Technical Note

Project: Crown Street, Manchester
Client: Renaker
Ref: TS220375-N04-ISSUE03
Re: HSE Substantive response advice to LPA
Date: 8th September 2023
Author: H Parkes & D McMahon
Checked by: A. Foolkes

Table 1 – HSE comments and Tenos' responses for pgo-3550

Table 2 – HSE comments and Tenos’ responses for pgo-3552

Figure A.1 - Plot C7 design alterations

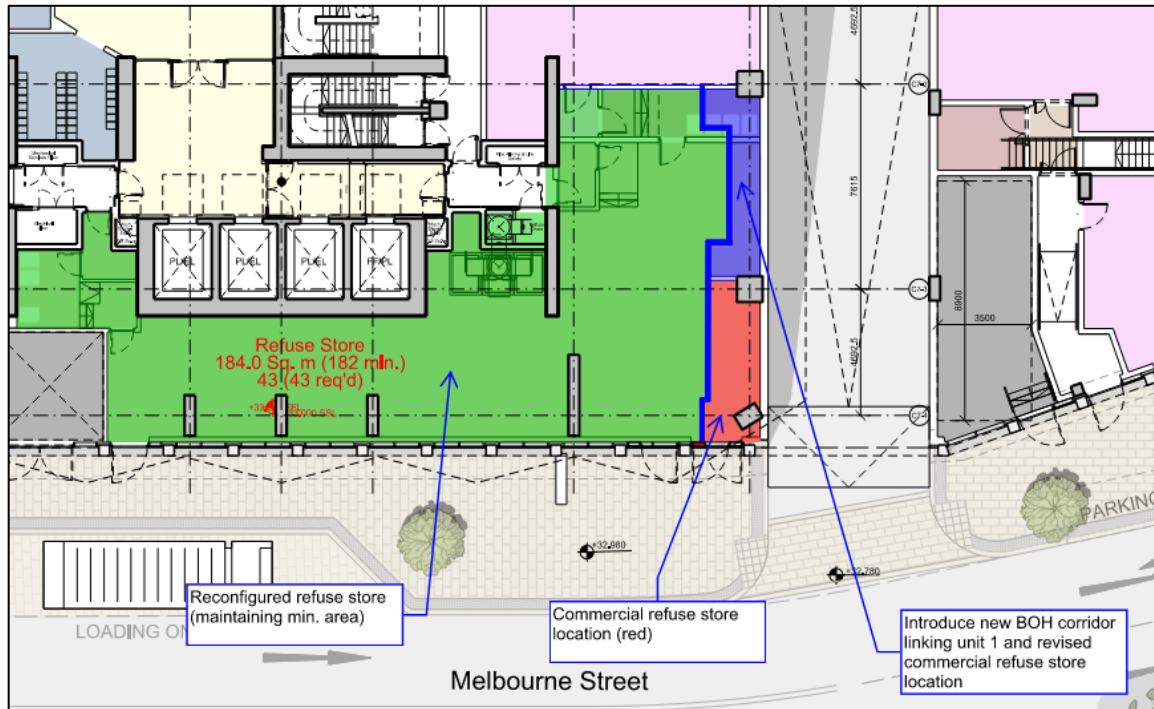
HSE Paragraph / Ref	HSE Comments	Tenos Comments
1.5 – 1.7	It is noted that commercial units C7-1, E1-1, 2, 3 and 4 and E2-2 link to the residential accommodation by way of the refuse holding stores and lobby to the fire-fighting stairs. Whilst it is noted that the stair to the ground floor commercial and the stair to the residential floors are separated by lobbies at ground floor, the adopted fire safety standard states: <i>“Any stair serving a dwelling within a mixed-use development should not communicate with any other occupancy, unless in accordance with a) or b)...a) In buildings having not more than three storeys above ground or access level (small buildings), common stairs that serve</i>	Thank you for your comment. The proposed amendments discussed below are shown in Figures A-1 to A-3. Unit C7-1 A fire-separated corridor and independent refuse store will be created for Unit C7-1 to remove the link between the commercial unit and residential accommodation. Unit E1-1, E1-2, E1-3 & E1-4 The commercial and residential refuse stores will be separated and accessed independently with no connection. An additional back-of-house corridor will be created to provide access from the commercial units to the refuse store.

In CS3, the design is to be amended to remove the connection between the residential and non-residential areas, as discussed in Table 1.
